## Upham / Kennedy Subdivision

## Environmental Review Team Report

# Upham / Kennedy Subdivision Haddam, Connecticut

July 1978

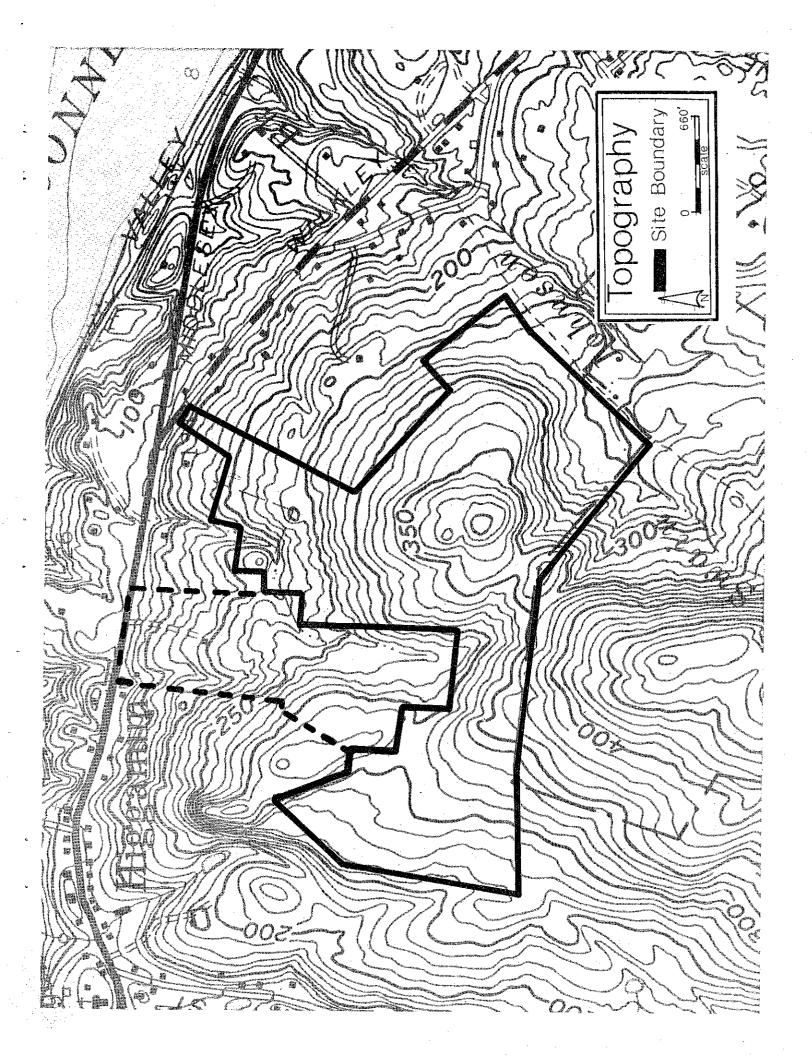
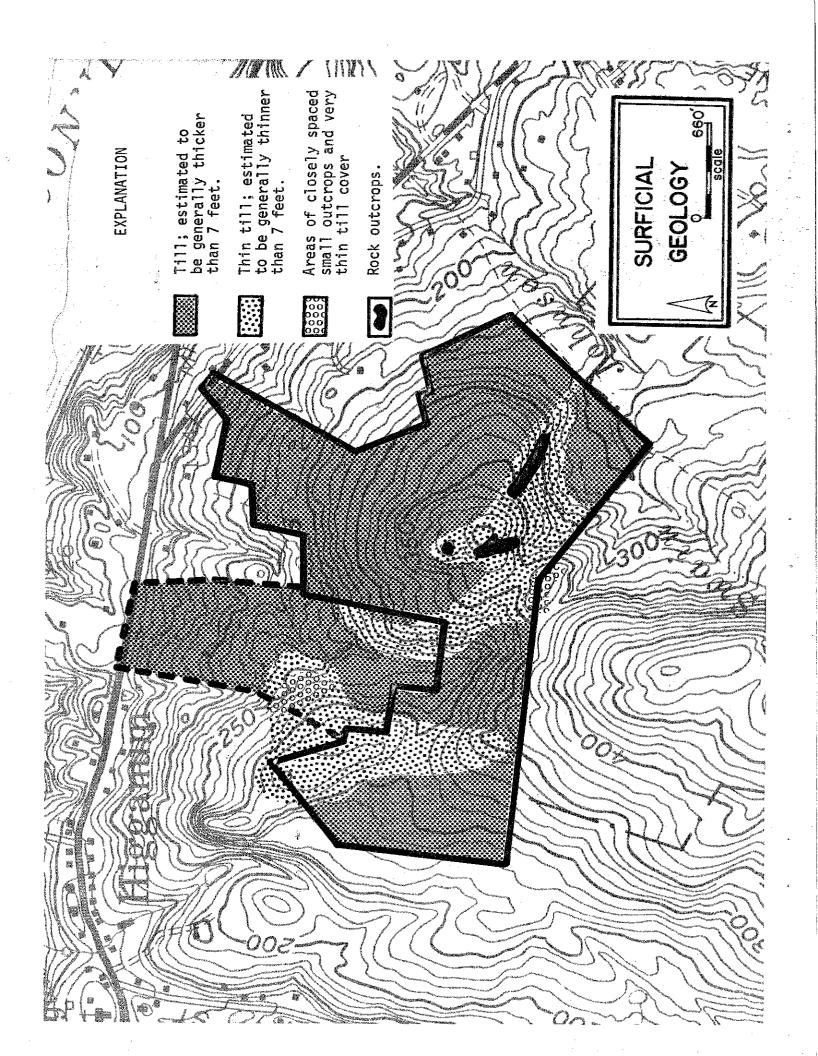
Briefly, Mr. Upham intends to subdivide the parcels in the manner shown in the accompanying illustration. One proposal includes 81 lots on  $135^{\pm}$  acres with access from Clark Road, the other includes the use of the Kennedy property, allowing for 100 lots on  $173^{\pm}$  acres with access on Clark Road and Middlesex Turnpike. These lots would be serviced by on-site septic systems and on-site wells. Both of these alternatives are very intensive uses of a site with major physical constraints to development.

In attempting to gain maximum utilization of the property within the zoning regulations, the subdivision plan proposes placing utilities and structures in areas both of very poor and of good characteristics for site development. Either increasing lot sizes significantly or grouping lots in areas of the site with the fewest constraints would allow greater flexibility to deal with the problems created by steep slopes, poor soils and ledge.

The Team recommends that the subdivision of the property into lots be based on the suitability and adequacy of specific areas within the site for subsurface sewage disposal systems, and on the availability and quality of individual water supply wells, rather than on the convenience of siting the lots or providing a maximum number of lots for economic purposes. Moreover, the location of houses within each approved lot should be contingent upon the careful and selective placement of wells and septic systems. The environment of the site necessitates giving the utmost consideration to the total interrelationship of topography, soil conditions, septic systems, and water supply.

A plan indicating lots which have suitable areas for septic systems and wells should be submitted for evaluation before a subdivision plan is approved for this site. The potential of this property to support the densities proposed is highly questionable. The majority of the area has severe limitations due to bedrock and steep slopes. Road construction costs would also seem to be a major obstacle to any development in these areas.

The subdivision plans show proposed roads with grades frequently between 5-10%. In both proposed plans, approximately 60% of the total roadways have grades exceeding 5%. In one section of the "Upham only" proposal, a section of proposed road appears to exceed a grade of 15% for a distance of 600'. Although the town subdivision regulations permit 10% road grades, such consistent use of steep roads creates an undesirable condition particularly during winter for school buses, emergency vehicles and trucks.

Unless a second access is obtained, the road system of both proposals will be a loop road and/or dead end road. Several of the dead end roads would exceed the town subdivision regulations that roads not be more than 1,000' in length and serve not more than 20 building lots.

Figure 2.

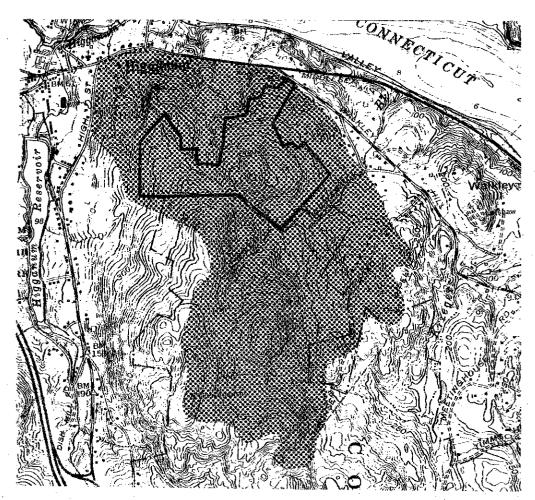
Although the subdivision plan was not, by itself, sufficient to allow the determination of the effects from storm sewering or wastewater discharges, an estimate may be made of the runoff change likely to occur from land use modification alone. Technical Release No. 55 of the Soil Conservation Service provides the technique used in formulating the estimate. The method involves the determination of runoff curve numbers, which relate amount of precipitation to amounts of runoff. It is estimated that development would increase the curve number on the properties by 8 (from 65 to 73 if both parcels are included and from 67 to 75 if only the Upham parcel is included). Peak flows in the streams that drain the properties are controlled by a watershed that is larger than the subdivision alone. This watershed, shown in Figure 2, contains approximately 745 acres. If no development occurs in the watershed outside of the proposed subdivision area, the overall runoff curve number would increase by about 1.5. Although no specific runoff volumes can be derived from this estimate, which is actually a simplification of the complete procedure outlined in Technical Release No. 55, it can be demonstrated that the curve number increment could lead to an overall runoff increase on the order of 5 percent. The rise in peak flow for a specific stream, however, would depend upon the layout of artificial drainage channels, roads, and other man-made features, and upon the many more subtle topographic and geologic characteristics of the properties.

A plan for storm-water routing should be included with the final subdivision proposal, and the effects of the subdivision on downstream culverts and floodprone areas should be weighed.

Figure 3.

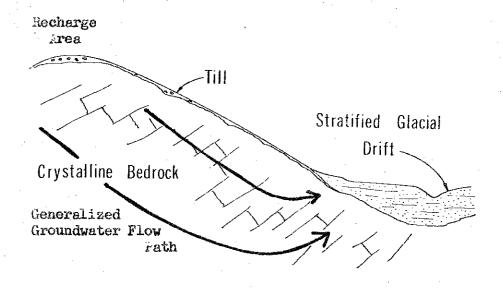
The major adverse hydrogeologic factors of the site as a whole are thinness of overburden, slope, and development density. High water tables may also be a problem in certain parts of the properties. Large daily wastewater discharges into zones of thin soils are likely to result in "outcropping" of leachate at the surface, especially in regions of steep slopes; in the introduction of poorly renovated effluent into the bedrock fracture system, the source of domestic water supplies for the subdivision; or both. Movement of groundwater within bedrock fracture zones is thought to be rapid, and contaminants such as nitrate, viruses, and bacteria are not extensively removed.\* The direction of groundwater movement within the fracture system is not known presently; however, the bedrock-controlled hill on which much of the Upham property is situated is effectively a recharge area (see schematic diagram, Figure 3), and it is therefore very likely that dis-

charges from septic systems in the development will become part of the water supply of local homes, including some homes that already exist. Such situations may not be of major importance if the soil is capable of properly treating the percolating effluent. However, in many areas of the proposed subdivision, the soil appears to be too thin to do more than a minor amount of purification.

prepared by D. Smith, D.E.P.

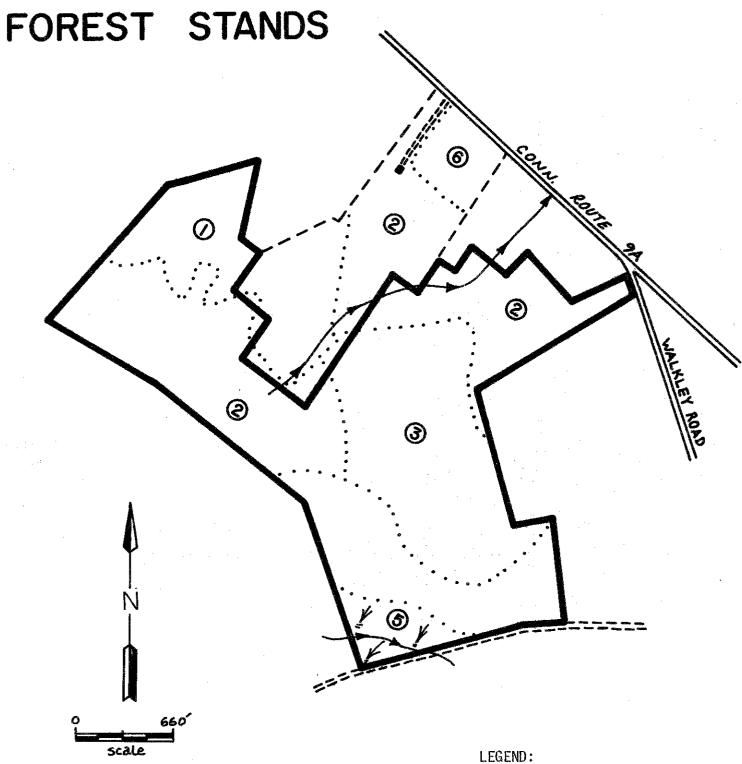
STAND ONE: This softwood and mixed hardwood area of approximately 21 acres is dominated by pole to sawlog size hemlock, white pine, red oak, scarlet oak, black birch and red maple in the wet areas. The understory is primarily composed of sapling size hemlock. As this area has steep terrain and shallow soils in many sections, it is best suited for softwood growth. A moderate sawlog harvest would encourage softwood reproduction by thinning the canopy and allowing more light to penetrate to the forest floor,

STAND TWO: This 74 acre mixed hardwood stand is primarily composed of pole to sawlog size red oak, scarlet oak, black oak, red maple, hickory, black birch and beech. Hemlock is scattered throughout the stand. The understory is composed of dense areas of mountain laurel which restrict any tree reproduction. Any development which takes place in this area should save as many of the trees with high aesthetic quality as possible.

STAND THREE: This 40 acre mixed hardwood area is dominated by red oaks, scarlet oaks, maples and hickories. The understory is almost entirely occupied by mountain laurel which severely limits tree reproduction. Due to shallow soils in this area, windthrow damage during development is a possibility. Retention of this stand as forested open space would be one solution to this problem.

STAND FOUR: This mixed hardwood area is composed of approximately 24 acres of red oak, black oak, black birch, red maple, hickory and ash. The understory is composed of sapling size reproduction of similar species. This area appears to have the best growing potential of the entire site and retention of as many trees as possible here should be encouraged.

STAND FIVE: This 7 acre wetland area is fully occupied by red maple, with some ash in drier sections. The understory is dominated by wetland shrubs such

as spicebush and witch hazel. It is recommended that this area be retained as open space as proposed.

STAND SIX: This 6 acre field is currently unforested. Foresting this area with softwoods available from the State or shade trees to enhance development value is a possibility.
